ENGINEERING REPORT

REPORT TITLE:	IMPROVED HR DESIGN SLOT POSITION FOR 953/958	REPORT DATE:	08/13/2021
REPORT NUMBER:	ENGREP 047	CREATED BY:	J. Majli Jauregui Ruiz
QA & ENGINEERING APPROVAL	CC:		
Hugo Amezcuita	Lulu Montejo, Lee Hunt, Marcos Chang, Hugo Amezcuita.

Figure. 1 DESIGN CHANGE PROPOSAL.

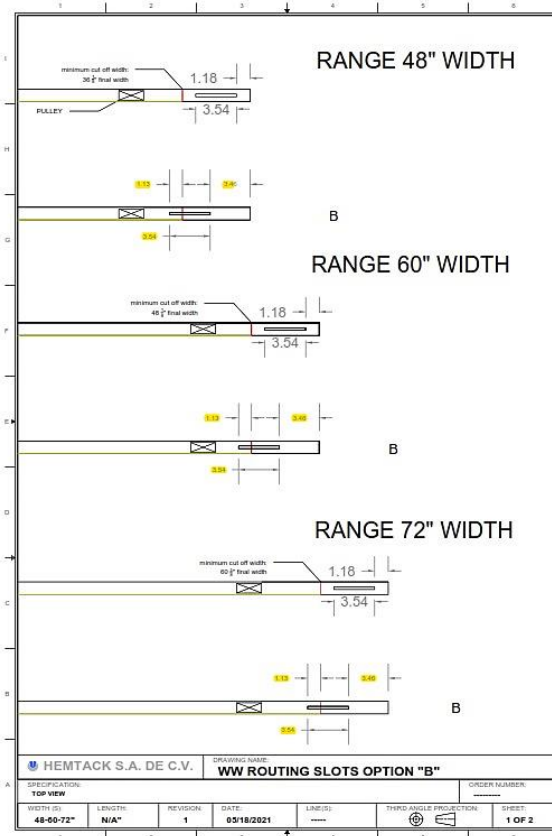
Based on an improvement proposal, a design change was requested with the objective of eliminating the need to perform the slot routing operation in the MTM production area. The proposal considers a specification change in regards of the location of the slots at each end of the woven wood shades headrail.

Figure. 2

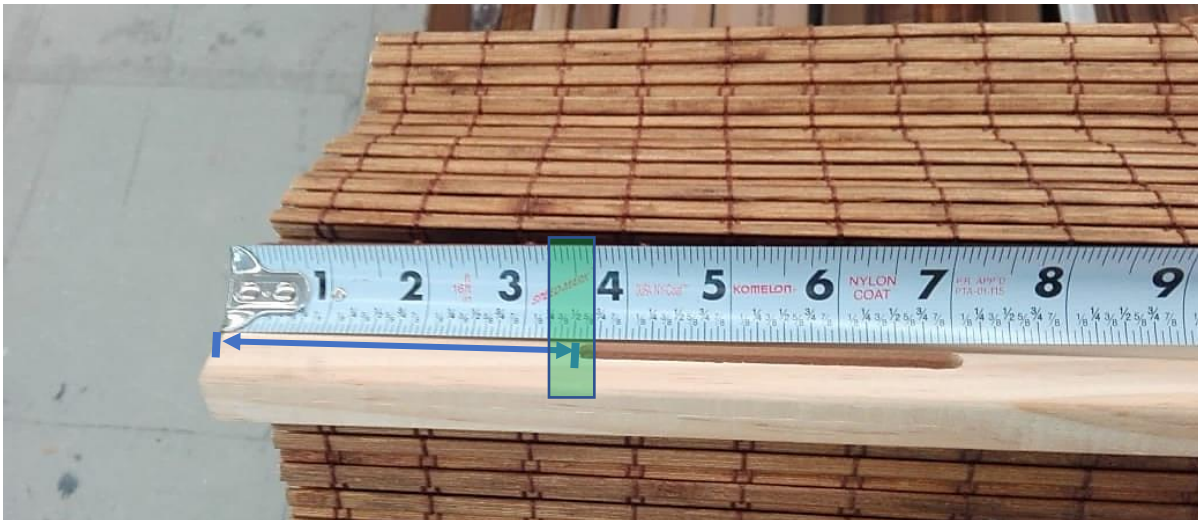
- Specification of the current design for the 48", 60" and 72" headrail, certain width adjustment end up requiring to perform the routing operation to redo the slots, mainly because the adjustments can go up to 5 ¾" and the slot is located around 1 ¼" inwards at each end (see image 3, 4 and 5).

Figure. 7 left side end view of the slot, right side example of the positioning at the ends.

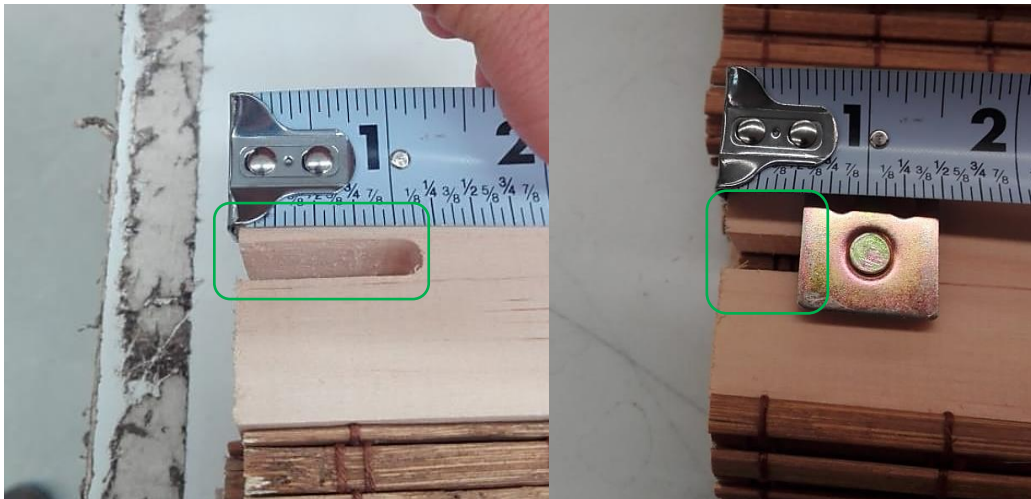
- As shown in figure 7, there is no interference with the position of the mounting hardware (bracket) and the returns in the case of outside mount shades.
- The formal change request will be submitted through an Engineering Change Order.
